Permit Type: Building/Residential/Misc/Porch
 Permit Number: B21001817
 Opened Date: 05/11/2021
 Description of Work: SFD/ CONSTRUCT 14' X 17' OPEN DECK W/STEPS AND 14' X 19' SCREENED PORCH

From: kathy hession <hessionkathy@hotmail.com>
Sent: Sunday, June 6, 2021 10:13 PM
To: Bricker, Robert
Cc: jphampstead@aol.com
Subject: Re: 6601 Blackwatch Lane_B21001817
Attachments: Plat 3808 photocopies.pdf

SUBJECT: Septic System Waiver Request

copy
Part of
Plot 3808
" = 30'

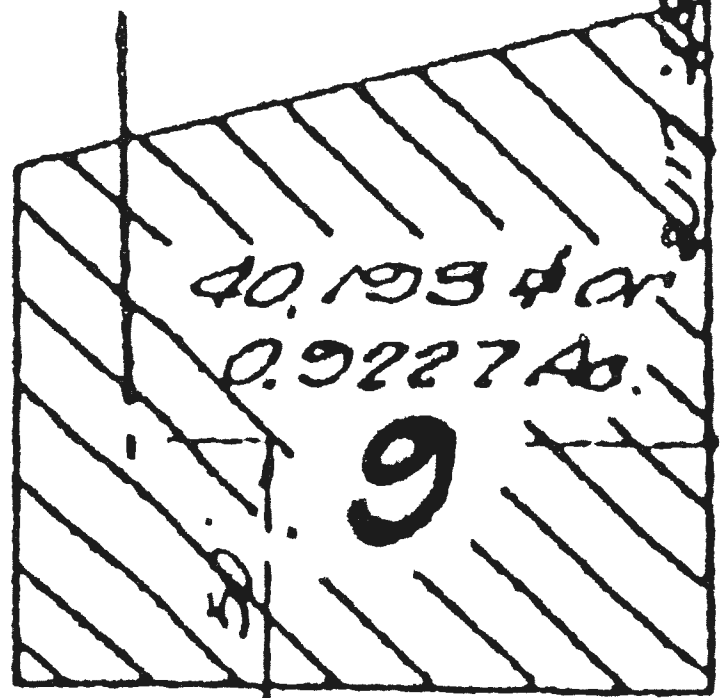
I have been assigned review of the proposal to construct a deck and a screen porch on your property. I found that the existing house was built partly within the sewage disposal area (SDA) that was approved on your property prior to subdivision and recorded on Plat 3808, Highland Lake. The SDA is set aside for the purpose of containing wastewater trenches for initial installation and occupation, and into the future until subsequent installations of repair trenches exhausts the SDA. The area requirement for the SDA is at least 10,000 sq.ft. and unencumbered by permanent structures, easements, or regulated setbacks. The Bureau of Environmental Health has not determined how much of the SDA your house is displaced. We have noted that the 100-ft setback from your well and the 100-ft setback from your back neighbor's well cover much of the remaining area of your lot that is not SDA, and that replacement drainfields for your septic system cannot be planned within the wells' setbacks.

- A. I am including a photocopies of Plat 3808 which are at scales of 1 inch equal to 50 feet and 1 inch equal to 30 feet. We are asking you to superimpose the SDA onto the revised Site Plan that you may use as an exhibit.
- B. There is not a record on file at the Bureau of Environmental Health which documents your septic systems' components locations. We are requiring that you specifically label the 'septic tank' location, and that you also illustrate and specifically label the location(s) of the 'dry well' and/or the 'trench' whereby the wastewater effluent is disposed.

ATTACH #1 (18 PAGES)

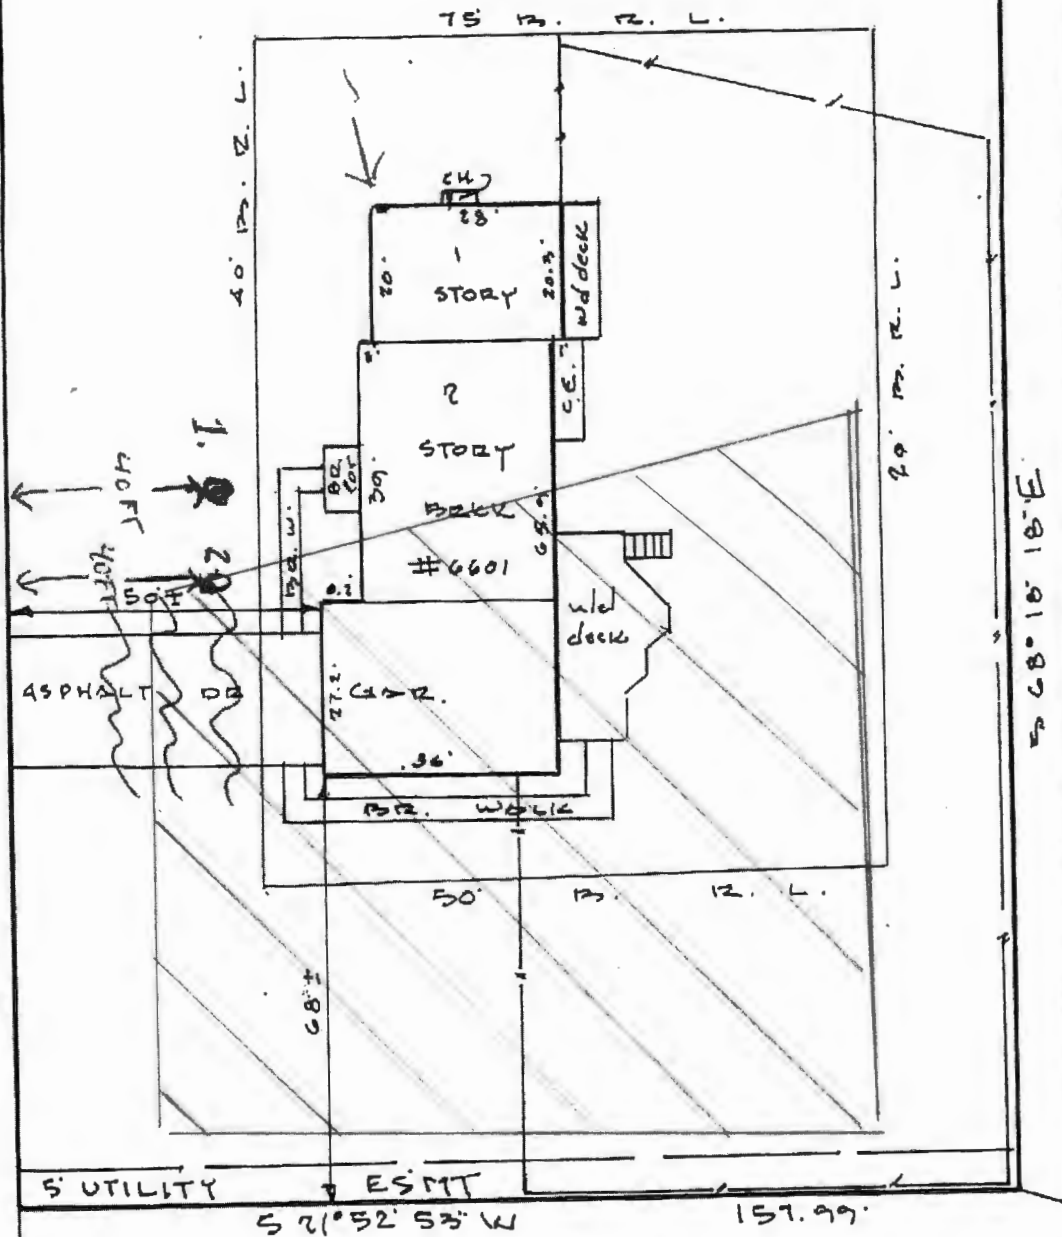
- As per his request I am submitting a diagram of my property where my intakes to my two tanks are situated in the front yard. Note: I cannot identify the drain field, although I suspect its located under my driveway. Incidentally, the deck is on the backside of the home.
- Please review the diagram and arrange for an inspection asap so that my builder can proceed with the deck replacement.
